TAHMOOR SOUTH COAL PROJECT GROUNDWATER ASSESSMENT INDEPENDENT REVIEW

**Prepared
for:**

**NSW Department of Planning
Industry and Environment**

**24 April
2020**

Figure 2 - Thirlmere Lakes longitudinal section

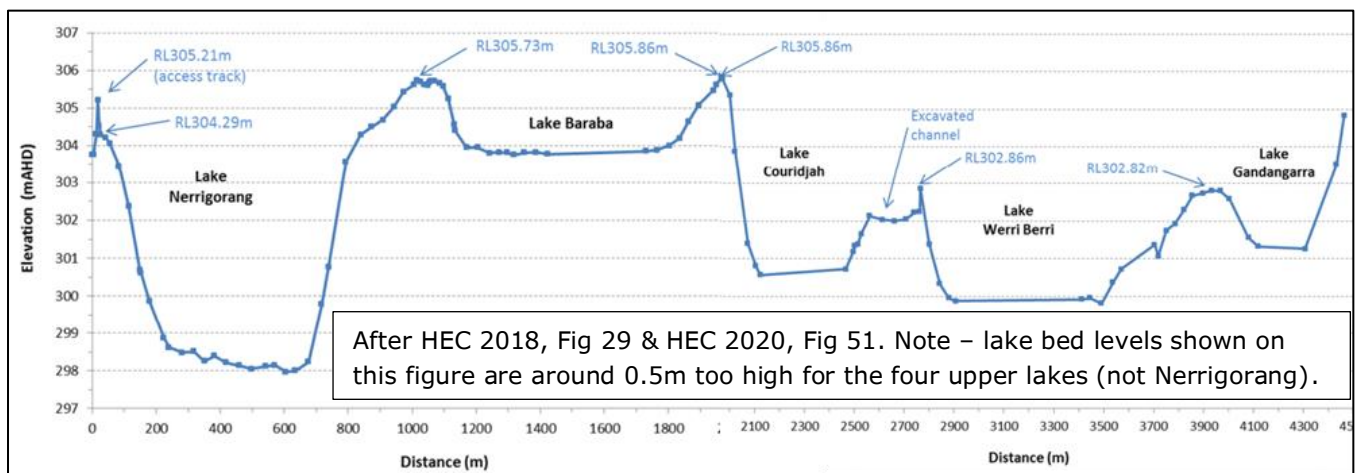
There is a longitudinal section for the lakes (Figure 2, after HEC 2018 & 2020), which identifies the bed and crest/overflow levels for the Thirlmere Lakes. There is also data available from four monitoring bores drilled in the Thirlmere Lakes area since 2011 (OEH 2016). The time series data are presented in Figure 3-16 (and Appendix H) of the groundwater assessment (HS 2018 & 2020), which notes that these are for 'post-mining' conditions only (i.e. post-Tahmoor North mining).

The data indicates that alluvial groundwater levels in GW75409/1 vary around 299-301 mAHD, consistently about 2 metres below the adjacent lake level at Lake Couridjah (nearest to Tahmoor). Although the groundwater level is often above the bed level of Lake Couridjah of about 300 mAHD (Figure 2), the lake level is consistently above the groundwater level, indicating losing lake conditions. The groundwater levels in GW75411 near Lake Gandangarra range through 294-299 mAHD, 4-6 metres below the lake level, also indicating losing conditions and clearly lower than the bed of Lake Gandangarra of about 301 mAHD, although this is less definitive as GW75411 monitors the Hawkesbury Sandstone, not the alluvium. The levels in GW75410 near Lake Nerrigorang, however, range through 297-306 mAHD, compared to its lake levels of around 299.5-301.5 mAHD, indicating variably gaining to losing conditions.

Given the above conceptualisation of mostly losing lake conditions (except for a variably losing/gaining Lake Nerrigorang), it can be argued that an appropriately simple/robust approach has been applied to the EIS groundwater assessment (HS 2018) in terms of specifying constant lake levels in the groundwater model to represent typical (median) operational conditions (i.e. rather than transient/dynamic lake levels). The model performance adequately represents these groundwater levels in terms of the losing condition of most lakes, but does not perform as well for the variably losing-gaining Lake

Nerrigorang, especially as that modelled constant lake level of 301 mAHD (HS section 4.4.3) is similar to the modelled groundwater level at GW75410 (HS Appendix H), which does not reflect the more variable measured range (297-306 mAHD). For the Amended Project Report, the groundwater model was updated with time-varying lake levels for the history-match period (HS 2020), but constant lake levels were again applied to the prediction period. This is justified with reference to the small volumes involved in the lake-aquifer exchange fluxes, whether or not the lakes are represented with time-varying levels.

Figure 3 - mapped faults and Tahmoor longwall layout (HS 2020, fig. 3-11)

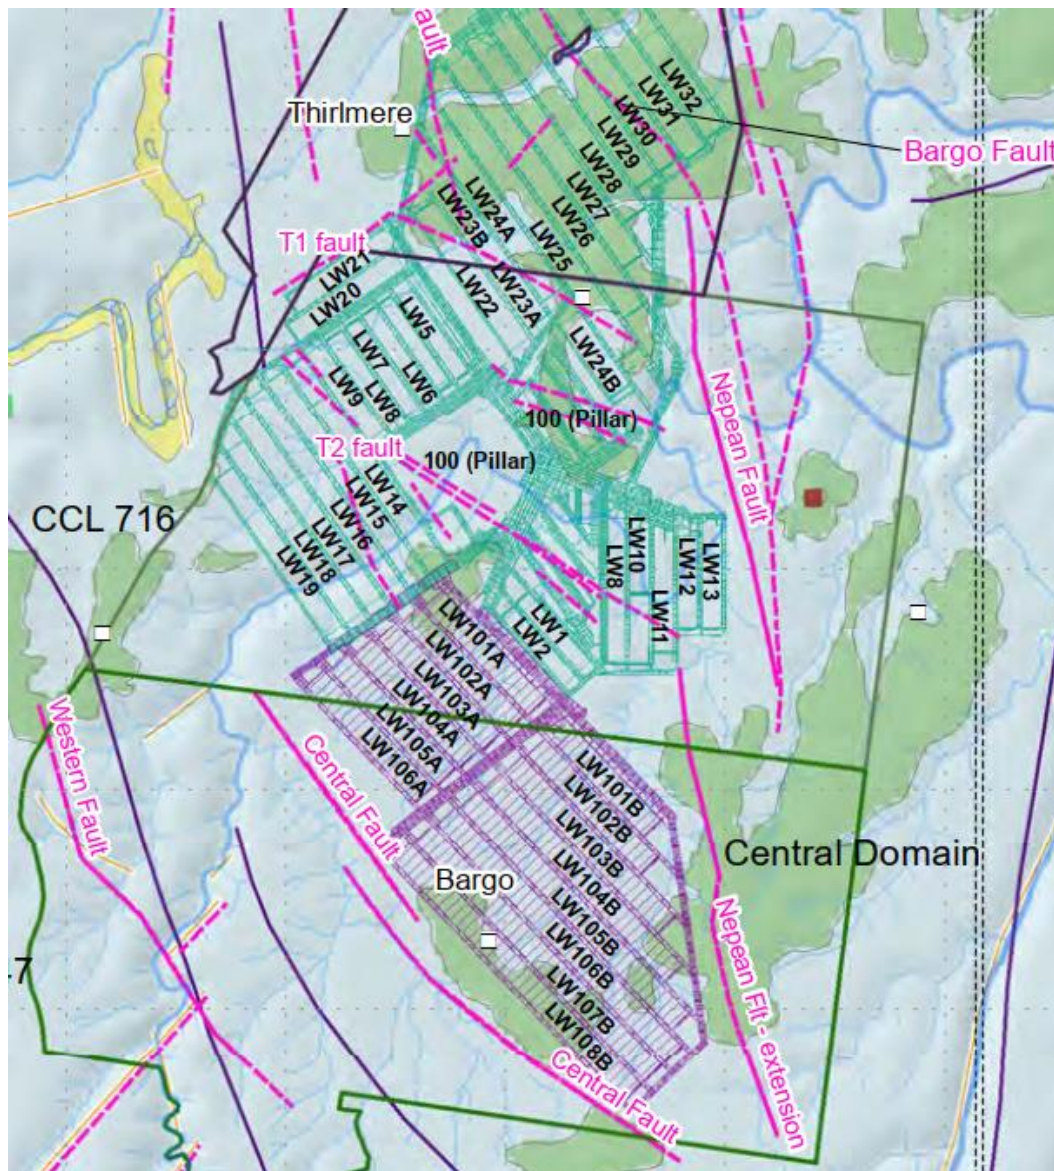
While the assessment has adequately investigated the mapped faults in the area (Figure 3, next page), it could be argued that the assessment has not investigated the potential for fault connection between Tahmoor South and Lake Nerrigorang.

It could be argued that investigation of such a potential connection is warranted in the context of the high value Thirlmere Lakes. Furthermore, it is noted that Lake Nerrigorang is the only lake that exhibits hydraulic connection with the water table (i.e. it is variably gaining/losing while all other lakes are above the water table and are losing). This means that there is theoretical potential for enhanced leakage from Lake Nerrigorang (and only that lake) in response to drawdown that may propagate via a theoretical fault that may connect with Tahmoor South.

A hypothetical fault connection has already been investigated in terms of extending the mapped length of the T2 fault to connect the mine workings with the Thirlmere Lakes alluvium, and applying increased hydraulic conductivity parameters to the T2 fault (Scenario v6TR073 listed in the APR Table 5-1). This scenario also increased the parameters for the other mapped faults proximal to Tahmoor; Central, Western, southern Nepean and T-faults. The model results were not sensitive to this scenario; in relation to the T2 fault extension because the Thirlmere Lakes are losing systems already at the maximum rate (except for the losing/gaining Lake Nerrigorang, which is 1-2km distant from the T2 alignment).

A similar scenario, albeit more hypothetical, could be envisaged to invoke a transmissive fault connection from Tahmoor South to Lake Nerrigorang. The obvious candidate with an appropriate orientation is the mapped Central Fault, the northern extent of which is level with (but west of) the northern end of the Tahmoor South panels, about 4km south the lake. It is understood that the panel layout is designed to avoid the Central Fault. While the Tahmoor model has already applied high values of hydraulic conductivity to the Central Fault as part of the T2 fault scenario, this test did not extend the fault north towards the lakes (because that is not consistent with the mapping).

This reviewer believes that the assumptions required to invoke such a hypothetical scenario regarding fault connection to Lake Nerrigorang are not justified, given that:

- there are no mapped faults that connect the lake to the mine workings and there is no secondary data (e.g. hydraulic heads or gradients) that indicate the effects of any fault in that area;

- most faults in the area are characterised as not transmissive, except for major faults (e.g. Nepean, Central), so logic would hold that there should be some evidence for such a major transmissive fault.

Having said that, it would not be a major exercise to conduct such a study of potential fault connections as part of an expanded uncertainty assessment.
